PREPARED FOR THE PLAN COMMISSION

Project Address: 223 South Pinckney Street (District 4- Ald. Verveer)
Application Type: Planned Development Alteration and Certified Survey Map
Conditional Use and Demolition Permit
Legistar File ID # [55916](#), [55921](#), [56121](#), & [56288](#)
Prepared By: Kevin Firchow, AICP, Planning Division
Report includes comments from other City agencies, as noted
Reviewed By: Nan Fey, Interim Director, DPCEd

Requested Action: The applicants request approval of the following: 1) Zoning Map Amendment to approve a revised Specific Implementation Plan and 2) Two-lot Certified Survey Map (CSM). **** NOTE **** The re-approval of the 2017 Conditional Use and Demolition Requests were originally included in this review to extend those approvals to correspond with the timeline for the Planned Development. The City Attorney’s Office has reviewed these requests based on recent changes in state law and the subsequently approved minor alterations, and has determined that the previously approved demolition and conditional use requests are valid until April 2024.

Proposal Summary: This request includes modifications to an approved 253-unit hotel and mixed use buildi

Above: West Wilson Street - Lower Levels of Hotel
March 22, 2017 Plans

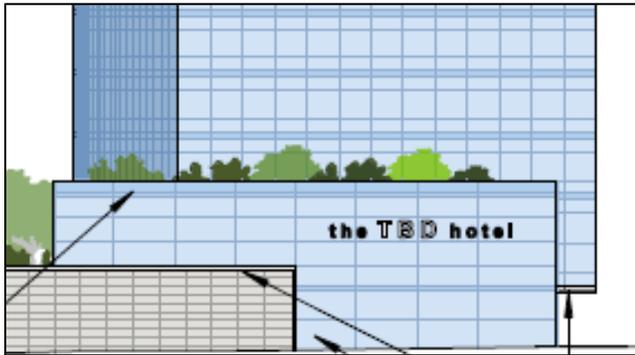
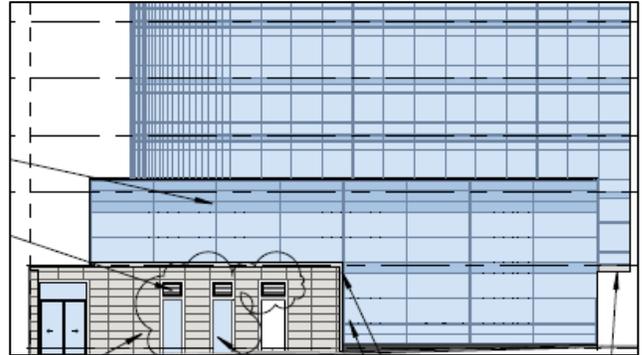
Corresponding façade changes are proposed to the East Wilson and Doty Street façades. Along Wilson Street, the previously approved underground parking entrance is now comprised of a door and spandrel-clad panels. Along Doty Street, additional windows and doors to an enclosed bike parking area are now proposed. No changes are proposed along South Pinckney Street.

Alterations to approved Planned Developments require review by either the Urban Design Commission (UDC) or the UDC Secretary. Considering the limited scope of changes above grade, the UDC Secretary has reviewed this request on behalf of the Commission. The Secretary believes that the removal of the parking ramp access and the corresponding East Wilson Street façade modifications improve the pedestrian character of this block face.
